BOLLETTINO TECNICO

N° **139-414**

SUBJECT

BRACKETS NOSE INSTALLATION.

Figure 1

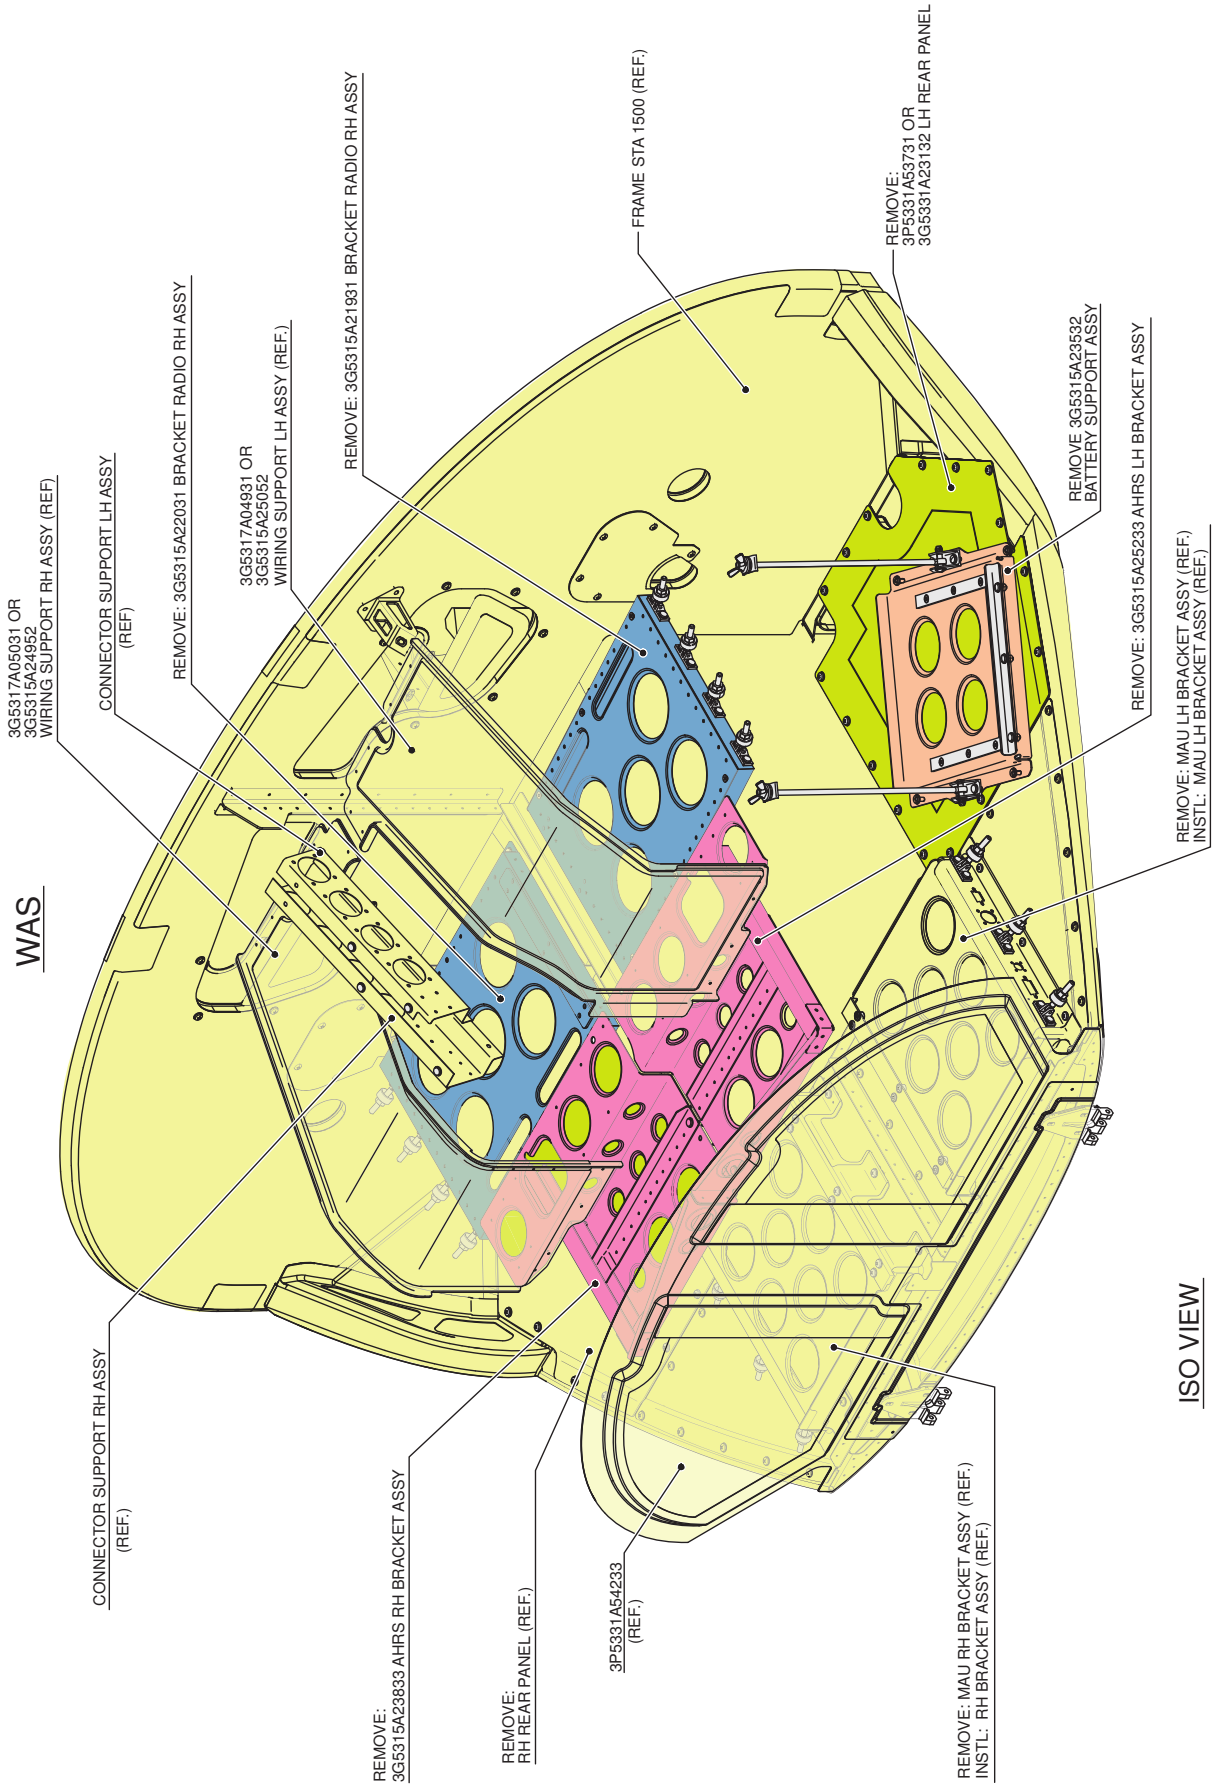
In order to improve the operative reliability of the Automatic Flight Control System (AFCS), a dedicated retromod has been developed to allow the installation of new improved structural supports replacing the following existing ones:

18. With reference to Figure 1 thru 3, perform the bracket nose installation retromod P/N 3G5306P55211, as described in the following procedure:
 - 18.1 With reference to Figure 1, remove the bracket radio LH assy P/N 3G5315A21931.

- 18.2 With reference to Figure 1, remove the bracket radio RH assy P/N 3G5315A22031.
 - 18.3 With reference to Figure 1, remove the AHRS LH bracket assy P/N 3G5315A25233.

- 18.4 With reference to Figure 1, remove the AHRS RH bracket assy P/N 3G5315A23833.
 - 18.5 With reference to Figure 1, remove the MAU LH bracket assy P/N 3G5315A26131.

- 18.6 With reference to Figure 1, remove the MAU RH bracket assy P/N 3G5315A26331.
 - 18.7 With reference to Figure 1, remove the battery support assy P/N 3G5315A23532. Retain n°2 tie rods P/N A469A001A285, n°2 strips P/N 999-0500-95-101, n°2 bushings P/N 999-0050-36-101, n°2 washers P/N NAS1070-416 and n°2 nut plain wings P/N MS35426-14 for later reuse.

- 18.8 In accordance with aircraft configuration and with reference to Figure 1, remove the LH rear panel P/N 3P5331A53731 or P/N 3G5331A23132.
 - 18.9 With reference to Figure 4 view D, drill n°4 holes \varnothing 14.25÷14.48.

Figure 2

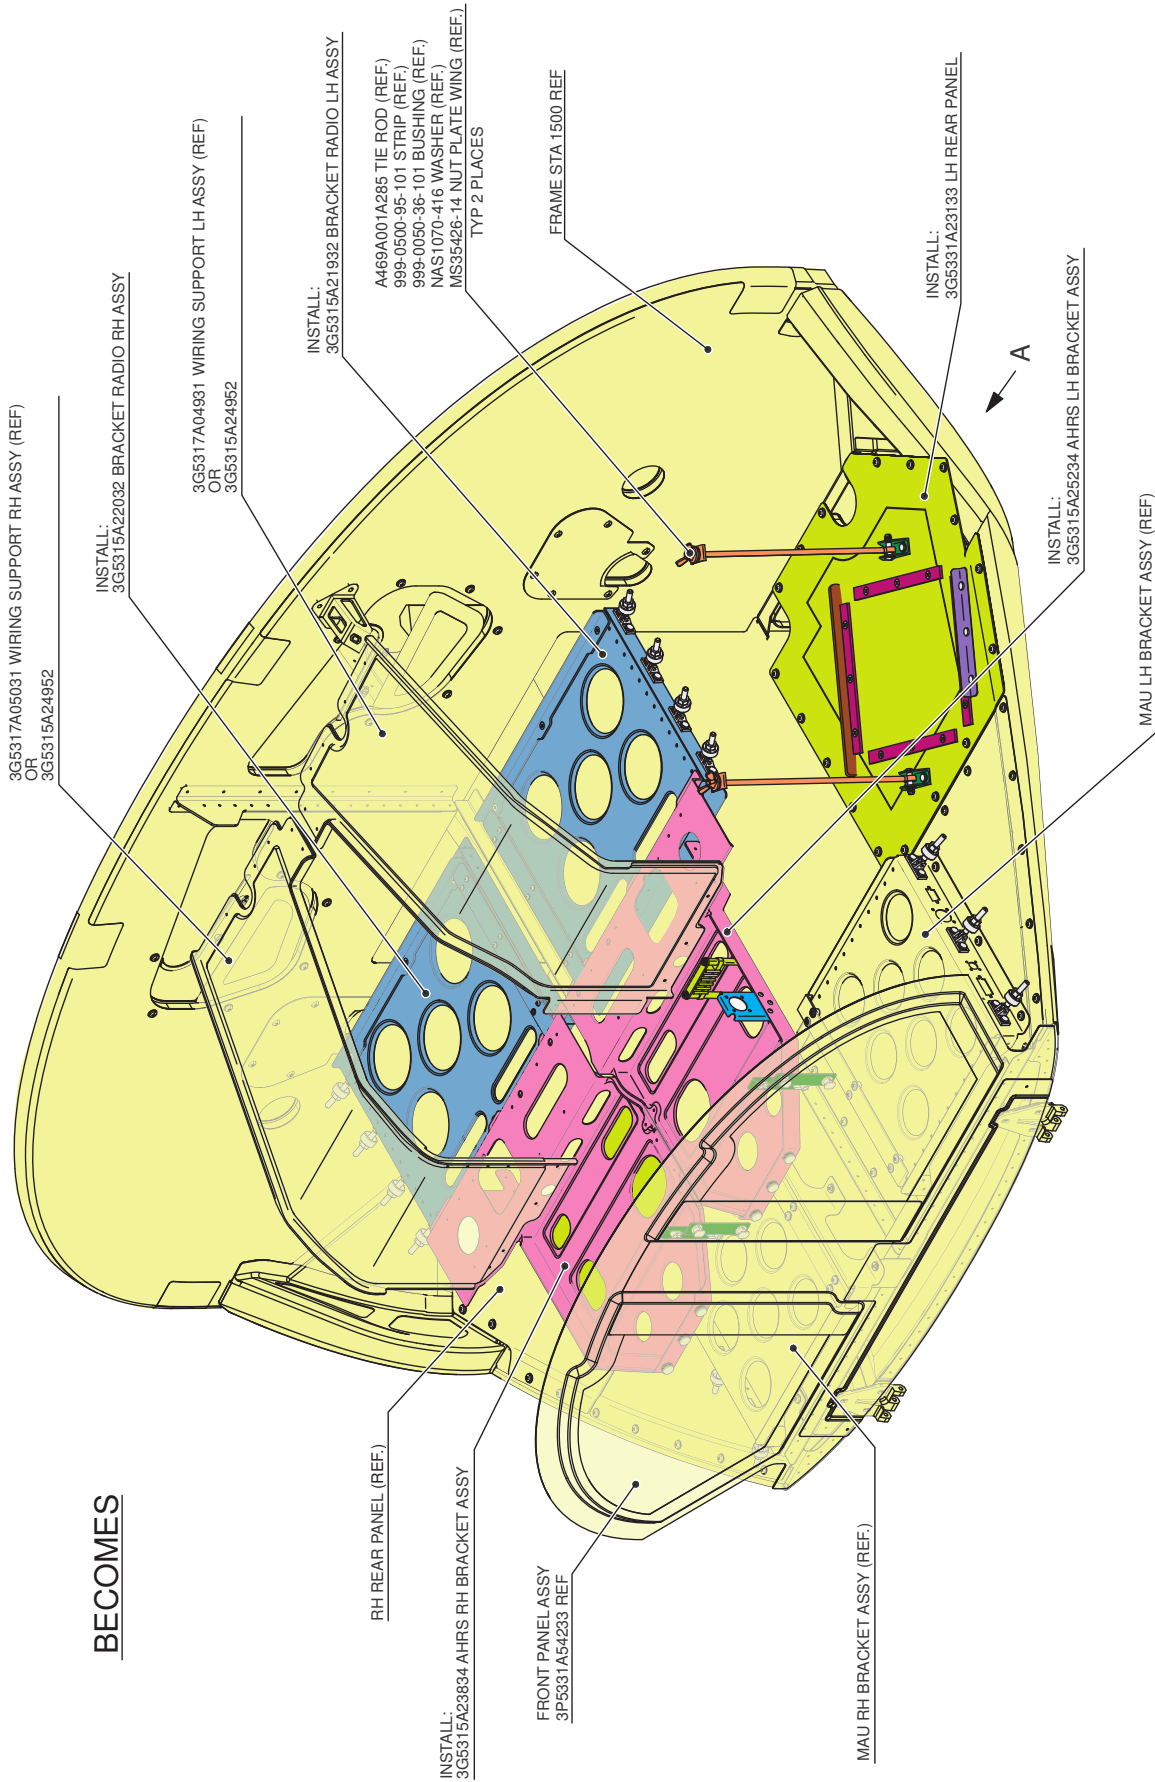
- 18.12 With reference to Figure 2 and Figure 3 section D-D, install the bracket radio LH assy P/N 3G5315A21932 by means of n°6 screws P/N MS27039-1-04 and n°6 washers P/N NAS1149D0332K.

- 18.27 With reference to Figure 2, temporarily locate the wiring support LH assy P/N 3G5317A04931 or P/N 3G5315A25052 and countermark position of n°4 holes.

18.46 With reference to Figure 2, install LH rear panel P/N 3G5331A23133 by means of existing hardware previously removed.

18.54 With reference to Figure 2, reinstall n°2 tie rods P/N A469A001A285, n°2 strips P/N 999-0500-95-101, n°2 bushings P/N 999-0050-36-101, n°2 washers P/N NAS1070-416 and n°2 nut plain wings P/N MS35426-14 previously removed by means of n°2 bolts AN24-17, n°4 washers P/N NAS1149D0416J, n°2 nuts P/N MS14145-4 and n°2 cotter pin

Figure 3

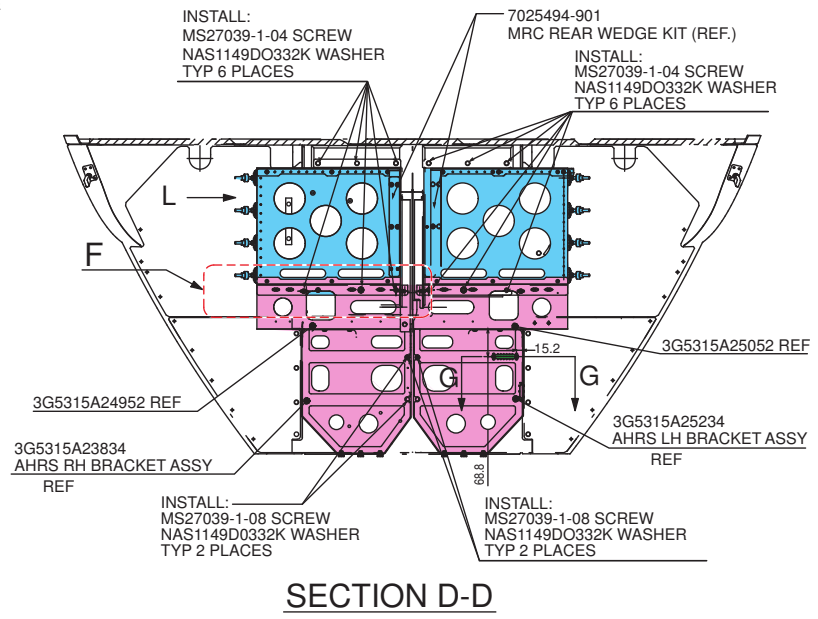
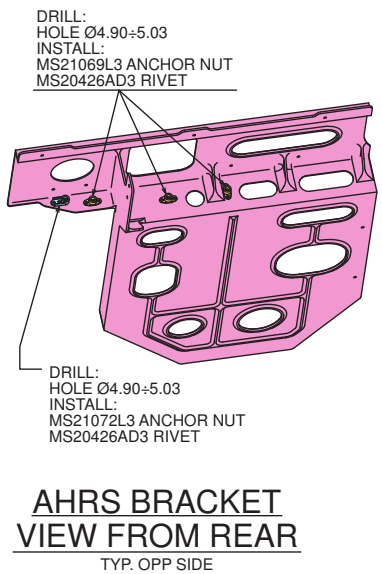
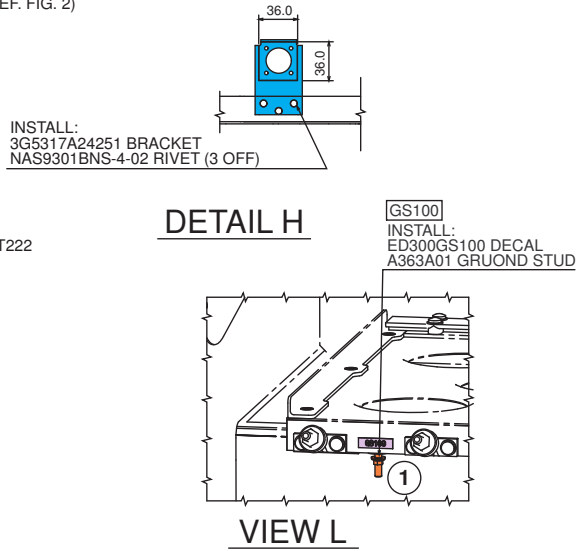
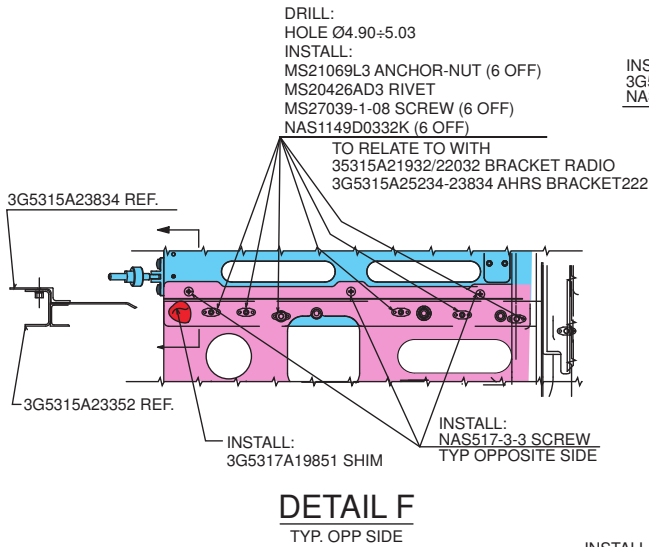
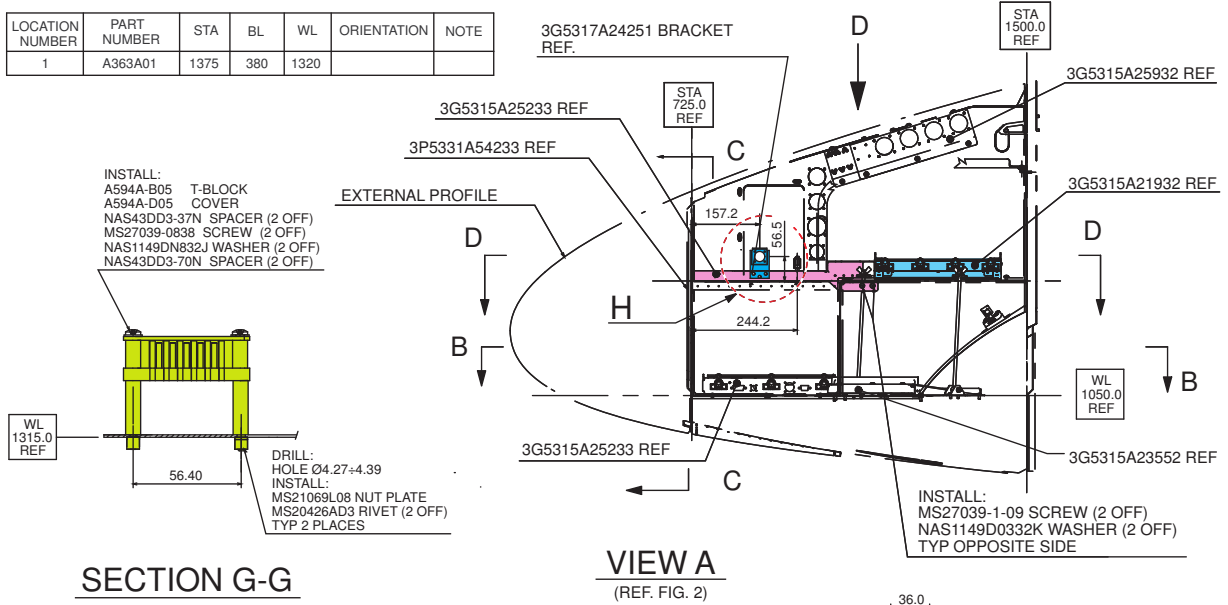
- 18.10 With reference to Figure 4 view D, install n°4 inserts P/N A8313A3CM by means of EA934NA adhesive.
 - 18.11 With reference to Figure 3, enlarge n°6 pilot holes to \varnothing 5.51÷5.64 on bracket radio LH assy P/N 3G5315A21932.

- 18.24 With reference to Figure 3 section D-D and detail F, enlarge n°6 pilot holes to $\varnothing 4.90 \div 5.03$, already present on AHRS LH bracket assy P/N 3G5315A25234.

- 18.25 With reference to Figure 3 section D-D and detail F, install n°6 anchor nuts P/N MS21069L3 by means of n°12 rivets P/N MS20426AD3 coordinating with previously performed holes on bottom side.

- 18.26 With reference to Figure 2 and Figure 3 view A, section D-D, detail F and Figure 4 section R-R, temporarily locate the AHRS LH bracket assy P/N 3G5315A25234, shims P/N 3G5317A19751 and P/N 3G5317A19851, by means of n°8 screws P/N MS27039-1-08, n°2 screws P/N MS27039-1-09, n°10 washers P/N NAS1149D0332K, n°3 bolts P/N NAS1802-3-6 and n°3 washer P/N NAS1149C0363R.

- 18.32 With reference to Figure 3 section D-D and section G-G, drill n°2 holes $\varnothing 4.27 \div 4.39$ on the AHRS LH bracket assy P/N 3G5315A25234.

- 18.33 With reference to Figure 3 section G-G, install n°2 nut plates P/N MS21069L08 by means of n°4 rivets P/N MS20426AD3.
- 18.34 With reference to Figure 3 section G-G, install T-Block P/N A594A-B05 and cover P/N A594A-D05 by means of n°2 spacers P/N NAS44DD3-37N, n°2 screws P/N MS27039-0838, n°2 washers P/N NAS1149DN832J and n°2 spacers P/N NAS43DD3-70N.

- 18.35 With reference to Figure 3 view A and detail H, install bracket P/N 3G5317A24251 in the indicated position, by means of n°3 rivets P/N NAS9301BNS-4-02.

Figure 4

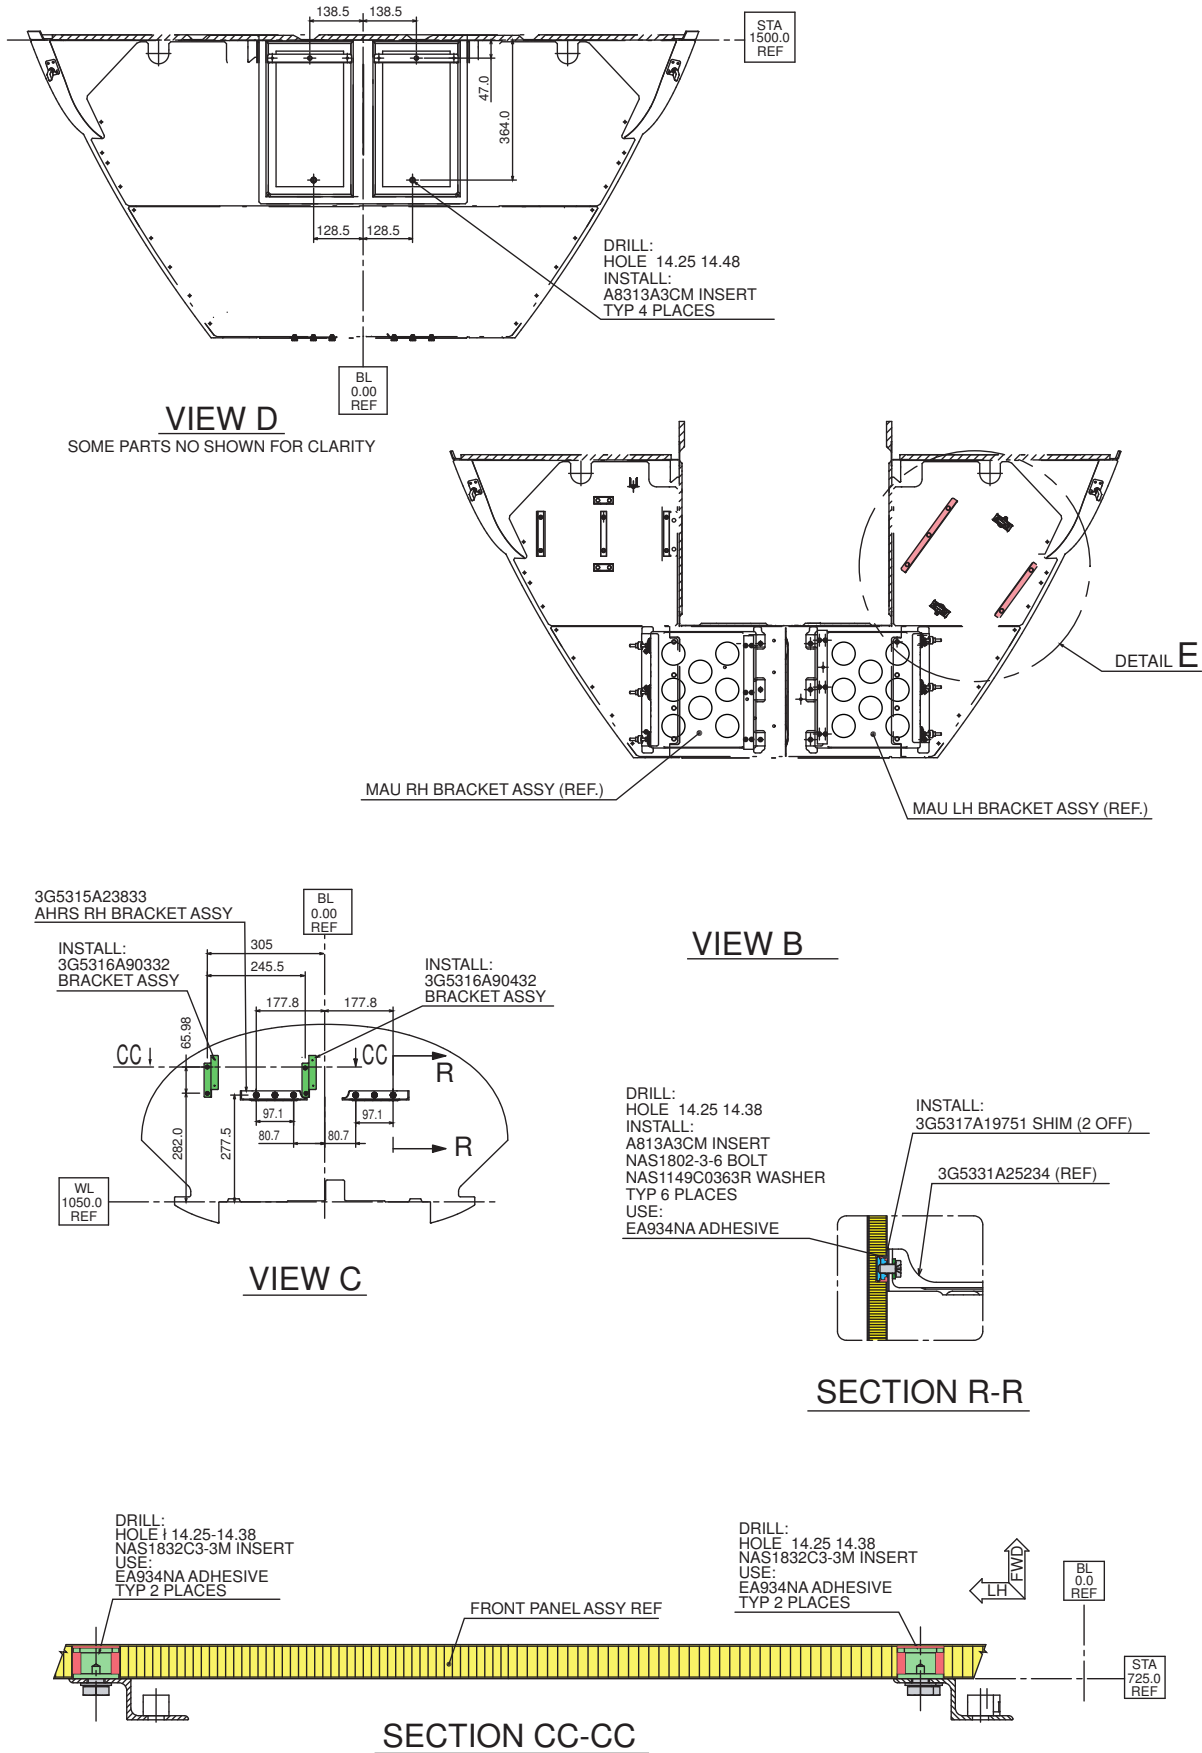
- 18.20 With reference to Figure 4 view C and section CC-CC, in order to avoid any interference with the AHRS LH bracket assy perform n°4 holes \varnothing 14.25÷14.38 and install n°4 inserts P/N NAS1832C3-3M with adhesive EA934NA, in a proper upper position on front panel assy P/N 3P5331A54233.
- 18.21 With reference to Figure 4 view C, install bracket assy P/N 3G5316A90332 and P/N 3G5316A90432 by means of the previously removed attaching hardware.
- 18.22 With reference to Figure 3 section D-D, temporarily remove the MRC rear wedge kit P/N 7025494-901 installed on the bracket radio LH assy P/N 3G5315A21932 and retain existing hardware for later reuse.
- 18.23 With reference to Figure 3 section D-D and detail F, temporarily locate the
